Save Our Country Spaces Response to WSP/SCC Technical Note

SOCS are in agreement with NORTH FRINGE PROTECTION GROUP'S POINTS.

Illustration & REFERENCES WESTERFIELD HOUSE 14/01039/FUL/ DC/17/05571

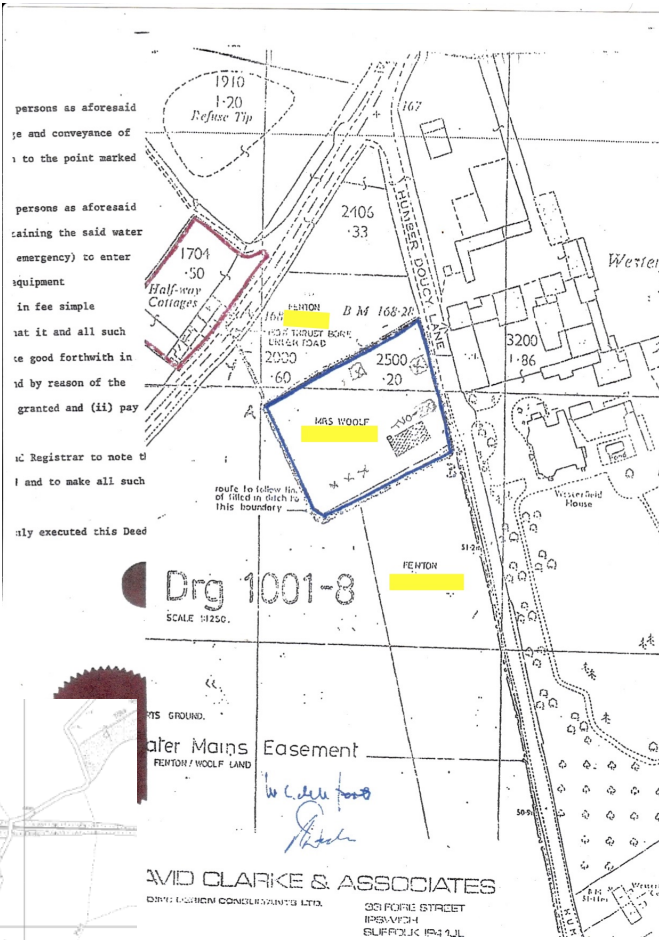
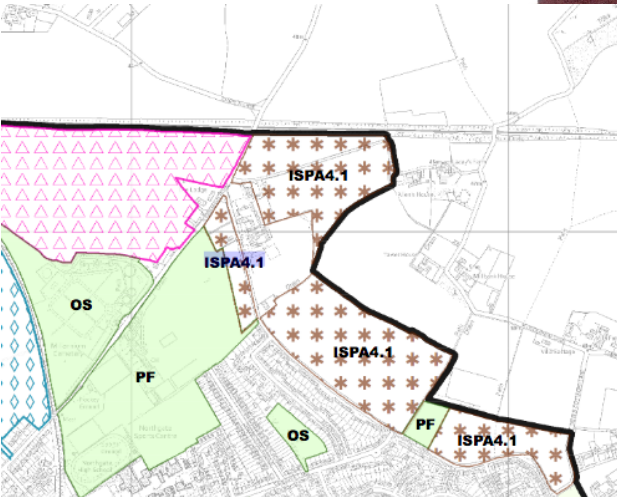
(i) The SCC modelling assumes that all necessary land for junction modifications Tuddenham/Humber DL is available. It isn't. There is a significant constraint being the wildlife site -ISPA4.1- which was 'Allocated' but now to be withdrawn. SCC said modifications will be required here (see ref page 2) as carriageway is 4.3 metres wide.

The road is very narrow and won't allow for Westerfield House Transport Strategy reserve matters solutions and proposals_ charity site has been approached for transport mitigation. This is likely precluded under the bequest outlined in the late Mr Woolf's will.

* ILLUSTRATION of Problem **page 2** Westerfield House/ Humber Doucy/Tuddenham Road is available but does not seem to be referenced? Sarah Hall Development Management Engineer Growth, Highways and Infrastructure²
